**LAND USE PETITION IN THE BOWIE PLANNING AREA**

Md.-National Capital Park and Planning Commission ID: Detailed Site Plan #07035  
Navy Federal Credit Union  
Bowie Advisory Planning Board # 07-10 Date: September 27, 2007

**SUBJECT:** Detailed Site Plan #DSP-07035  
Navy Federal Credit Union  
Lot 5, Block A, Bowie Gateway Center

**Subject:** Detailed Site Plan #DSP-07035  
Navy Federal Credit Union  
Lot 5, Block A, Bowie Gateway Center

CITY OF CAPITALS - NAVY FEDERAL CREDIT UNION  
BOWIE, MARYLAND

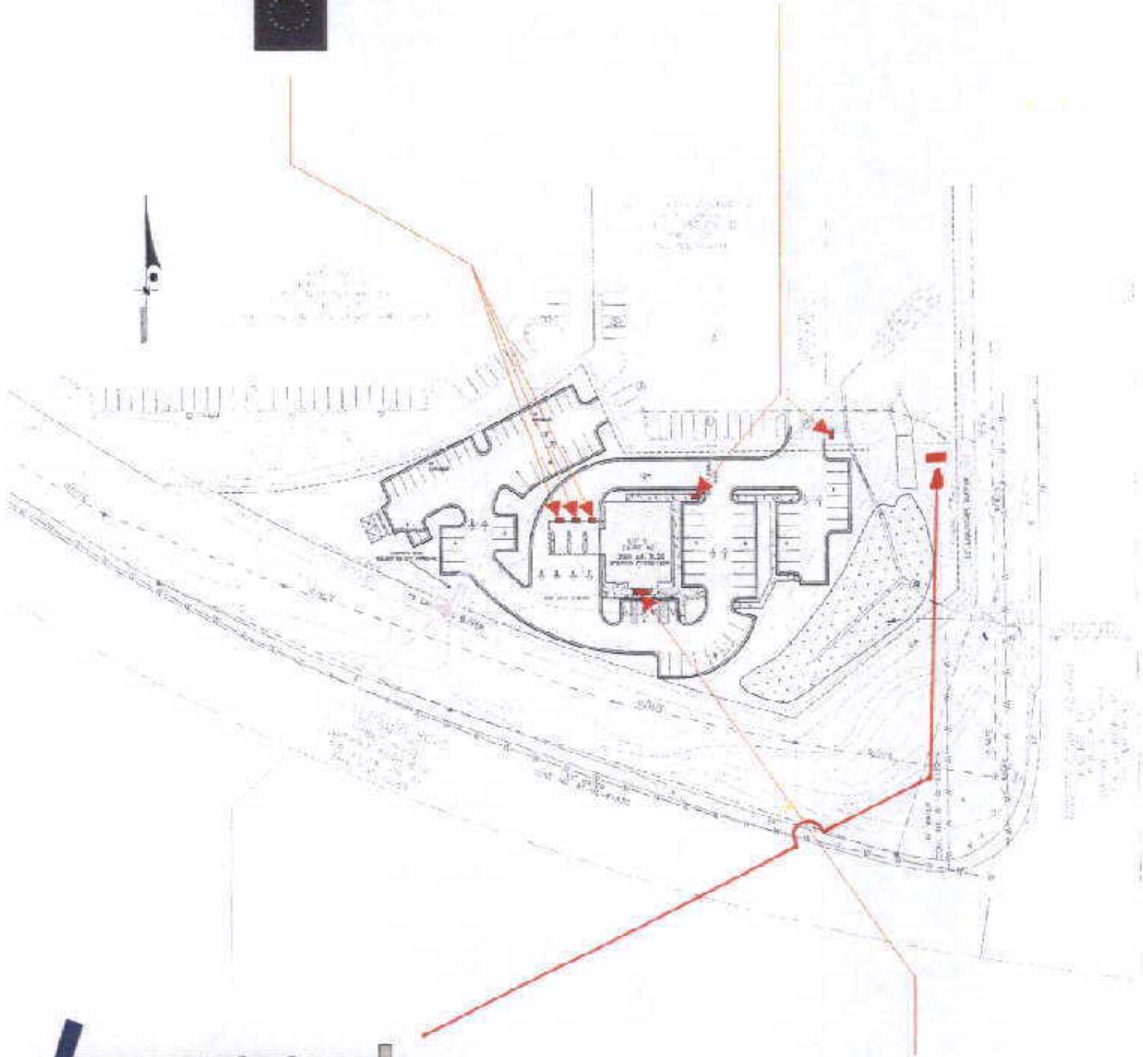
**COMMENT:** To enhance on-site traffic circulation, pavement-painted arrows delineating the two-way travel flow should be provided within the parking lot of Lot 5.

To avoid motorist confusion, two (2) "Do Not Enter" signs should be installed at the exit of the drive-through facility, adjacent to the crosswalk.

The eastern-most portion of the parking area, where six (6) spaces are proposed, ends in a dead-end, without providing an opportunity for motorists to leave without backing up if this lot is full. To remedy this situation, this parking area should be reserved for employee parking only and designated by signage, similar in design, style, height and area to the proposed on-site directional sign which should be located at the entrance to this parking area.

Five (5)-foot wide sidewalks are proposed within Lot 5 to connect portions of the parking lot to the building. To provide a pedestrian linkage between the subject site and the two (2) restaurants, it is recommended that the sidewalk be extended from where it presently terminates on Lot 6 and connect with the sidewalk proposed in the northern island in the parking lot of Parcel 5. Pavement-painted crosswalks should be provided to identify all pedestrian crossings.

Lastly, regarding sidewalk, the width of the sidewalk proposed on Lot 5 is five (5) feet. The width of the sidewalk on the approved DSP for the restaurants is six (6) feet. To have a consistent sidewalk width throughout the entire developed site, and to provide more area for pedestrians to walk, the width of all of the sidewalk on Lot 5 should be increased to six (6) feet.

1. Pursuant to City policy, all handicap parking spaces shall be painted blue in their entirety, in addition to the standard pavement-painted symbol and signage located at the head of each space. A note shall be placed on the plan indicating that all handicap spaces will be painted blue.
2. **Circulation and Access.**
  - A. Pavement-painted arrows delineating the two-way travel flow shall be provided within the parking lot of Lot 5.
  - B. Two (2) "Do Not Enter" signs shall be installed at the exit of the drive-through facility, adjacent to the crosswalk.

- C. The eastern-most portion of the parking area, where six (6) spaces are proposed in a dead-end configuration, shall be for employee parking only and shall be designated by signage, similar in design, style, height and area to the proposed on-site directional sign which should be located at the entrance to this parking area.
- D. The sidewalk shall be extended from where it presently terminates on Lot 6 (On the Border) and shall connect with the sidewalk proposed in the northern island in the parking lot of Lot 5. Pavement-painted crosswalks shall be provided to identify all pedestrian crossings.
- E. The width of all of the sidewalk on Lot 5 shall be increased to six (6) feet.

**SITE SIGNAGE FOR  
 BOWIE, MD.**

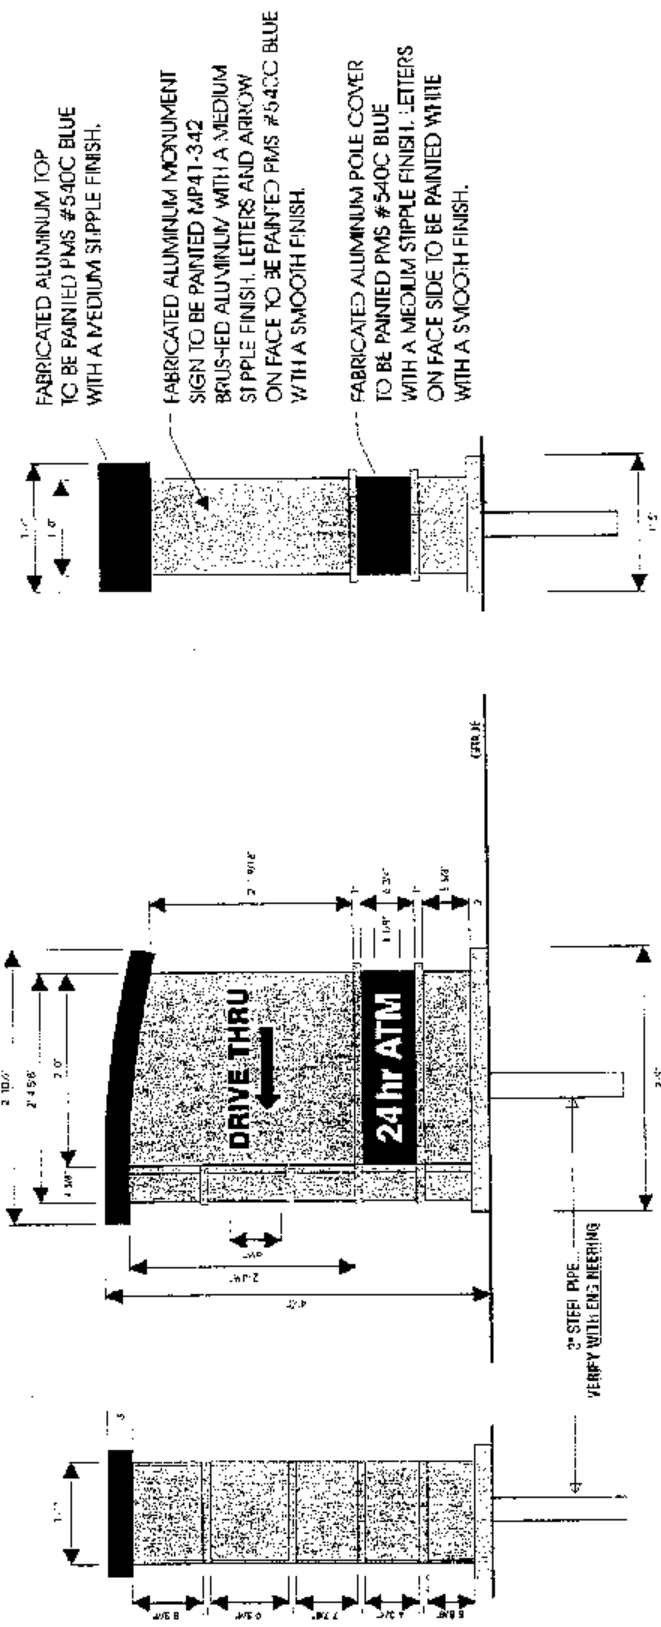
**COMMENT:** One (1) ground-mounted sign, 10.5-foot high with an area of 92.6 sq. ft., is proposed along the U.S. Route 301 r/w, abutting a 10-foot wide Public Utilities Easement (P.U.E.) (Attachment 5B). With respect to location, installing this sign 97 ft. from the U.S. Route 301 r/w, as required by City covenants, is unreasonable and would place it within an existing, fenced SWM facility. To be consistent with the location of the free-standing sign shared by Chili's and On the Border, and to provide improved visibility to the traveling public, it is recommended that the sign be situated a minimum of 40 ft. from the U.S. Route 301 r/w. To achieve this setback, a section of fencing around the SWM area should be realigned to accommodate the sign.

Two (2) on-site directional signs are proposed, each with on a solid base, with a height of four (4) feet at the locations shown on the site plan (Attachment 5C). The area of each directional sign is 9.6 sq. ft. Due to the potential of one (1) directional sign being located within a sidewalk and potentially creating a blind spot for drivers using the parking lot, it is recommended that this sign be deleted, and only one (1) directional sign be provided on the site, which should be located on the eastern side of the site's main driveway. With respect to height, directional signs are encouraged to be no higher than 2.5 ft., so as to not interfere with motorists' line-of-sight and vision to see other vehicles entering/exiting and within the parking area. It is

therefore recommended that the height of the directional sign be reduced from four (4) ft. to no higher than 2.5 ft. (Recently-approved banks in the City have complied with this height restriction.)

- A. If one (1) ground-mounted sign is approved, its height shall not exceed 10.5-feet and its area shall not exceed 92.6 sq. ft. This sign shall be situated no closer than 40 ft. from the U.S. Route 301 r/w. To achieve this setback, a section of fencing around the SWM area shall be realigned to accommodate the sign.
- B. If two (2) building-mounted signs are approved, one (1) shall be installed over the main building entrance on the southern elevation (facing MD Route 197) and shall have an area not exceeding 21.8 sq. ft., and one (1) shall be installed on the eastern elevation, facing U.S. Route 301, with an area not exceeding 21.8 sq. ft.
- C. The one (1) directional sign located within a sidewalk and potentially creating a blind spot for drivers using the parking lot,

shall be deleted. The second directional sign shall be relocated to the eastern side of the site's main driveway.

D. The height of the directional sign shall not exceed 2.5 ft.

FRONT ELEVATION  
FACES COLLINGTON ROAD

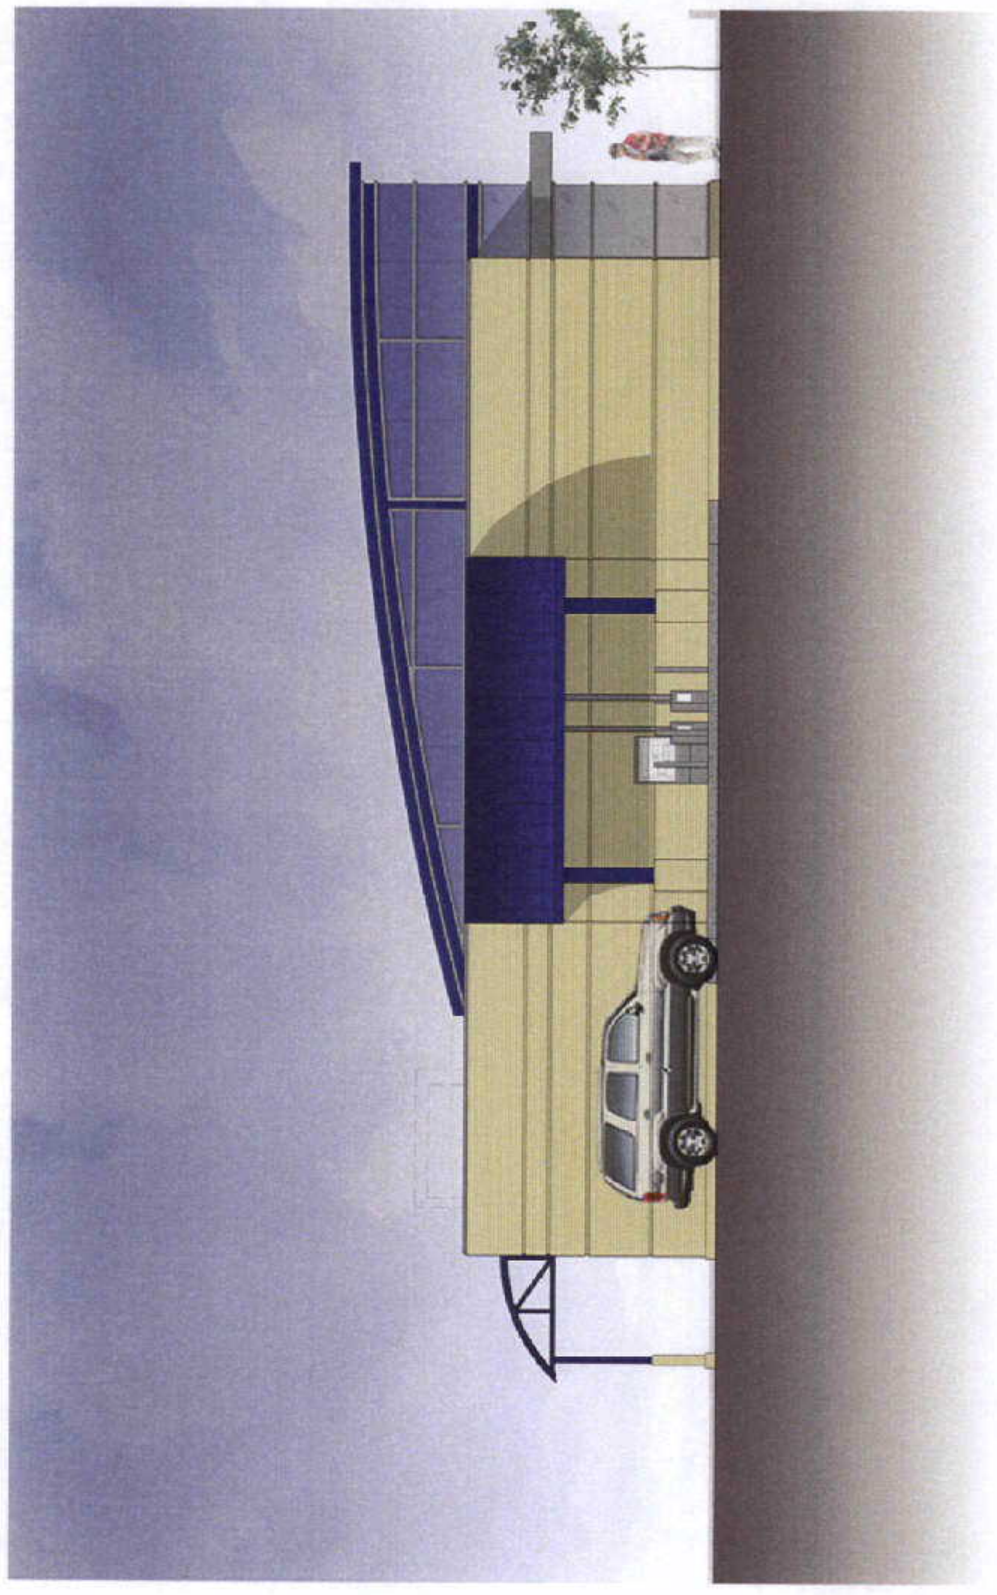
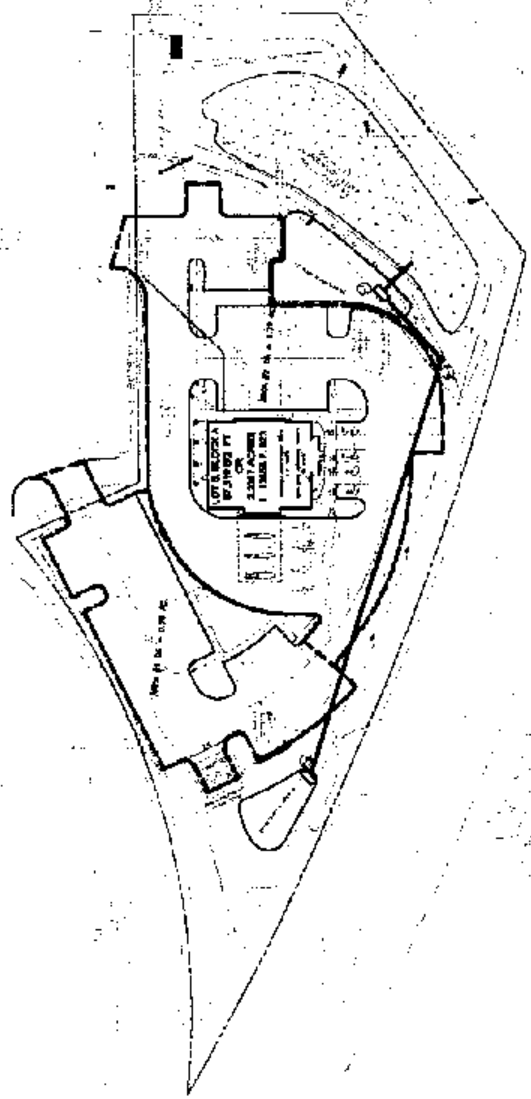
In addition to the proposed ground-mounted sign noted above, architectural building elevations (Attachments 6A and 6B) indicate two (2) building-mounted signs proposed: one (1) over the main building entrance on the southern elevation (facing MD Route 197), with an area of approximately 21.8 sq. ft., and one (1) on the eastern elevation, facing U.S. Route 301, also with an area of approximately 21.8 sq. ft. Total area of building-mounted signage proposed is 43.6 sq. ft., which is within the total area of building-mounted signage permitted by the Zoning Ordinance (104 sq. ft., based on the length of the wall with the main entrance to the building). Although approving two (2) building-mounted signs, in addition to the ground-mounted sign, violates the internal covenants for the development, such signage would be consistent with what has been approved for other developments in the Bowie Gateway Center. (The internal covenants are only enforceable by private property owners in the development. The City has no role.)

**COMMENT:** If the door on the northern (rear) building elevation (Attachment 6D) is proposed to be solid (vs. glass), it should be painted beige to match the color of the brick background wall.

To be consistent with other buildings approved in the Bowie Gateway Center and throughout the City, all roof-mounted HVAC equipment should be screened. The material and color of the HVAC screen wall should include the use of aluminum panels, blue or gray in color.

A. If the door on the northern (rear) building elevation is proposed to be solid (vs. glass), it shall be painted beige to match the color of the brick background wall.

B. All roof-mounted HVAC equipment shall be screened. The material and color of the HVAC screen wall shall include the use of aluminum panels, blue or gray in color.
